Hidden Village Subdivision

City of El Paso — City Plan Commission — 5/17/2018

SUSU18-00005 — Resubdivision Preliminary

1. Location Map
2. Preliminary plat
3. Application
4. Department Comments

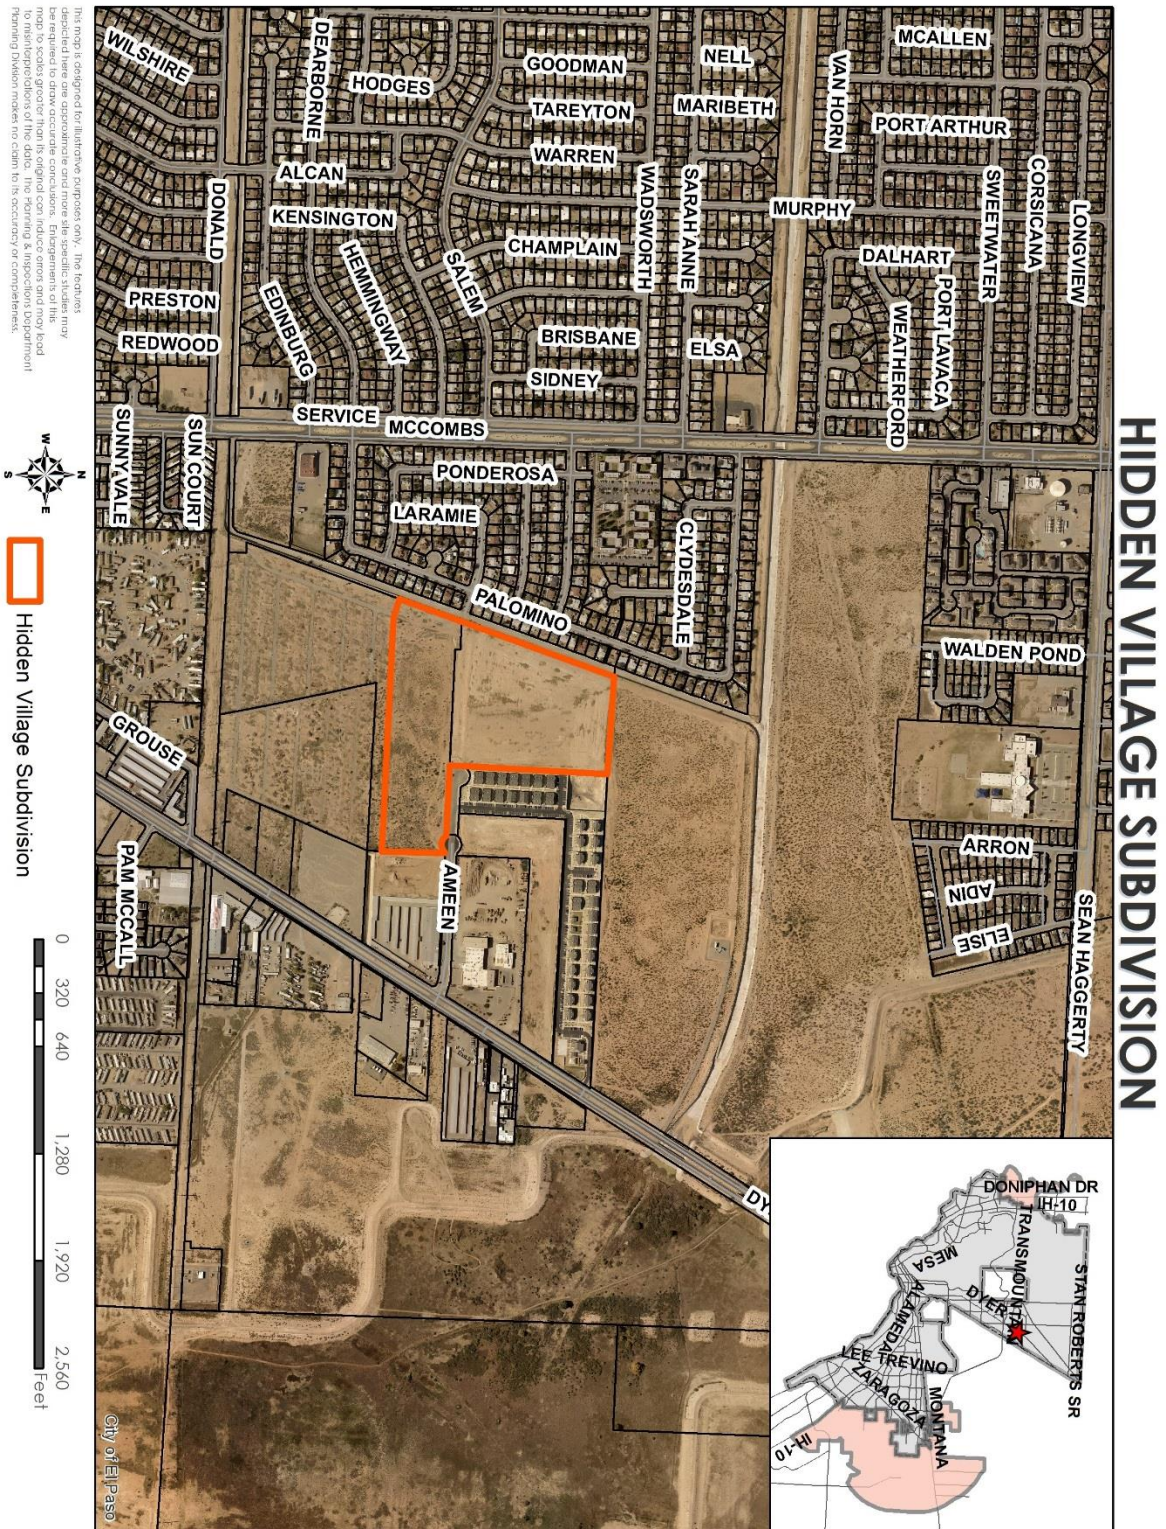
- Submit to the Planning & Inspections Department – Planning Division the following prior to recording of the subdivision:
 - a: Current certificate tax certificate(s)
 - b: Current proof of ownership.
 - c: Release of access document, if applicable.
 - d: Set of restrictive covenants, if applicable.
- Every subdivision shall provide for postal delivery service. The subdivider shall coordinate the installation and construction with the United States Postal Service in determining the type of delivery service for the proposed subdivision. In all cases, the type and location of delivery service shall be subject to the approval of the United States Postal Service.
- Ensure that intersections comply with Section 19.15.070 of the current code.
- Include missing lot number after Lot 14, Block 10.

1. Verify the pond dimensions comply with DSC and will have enough capacity to hold the developed runoff for a designed 100-yr. storm event.
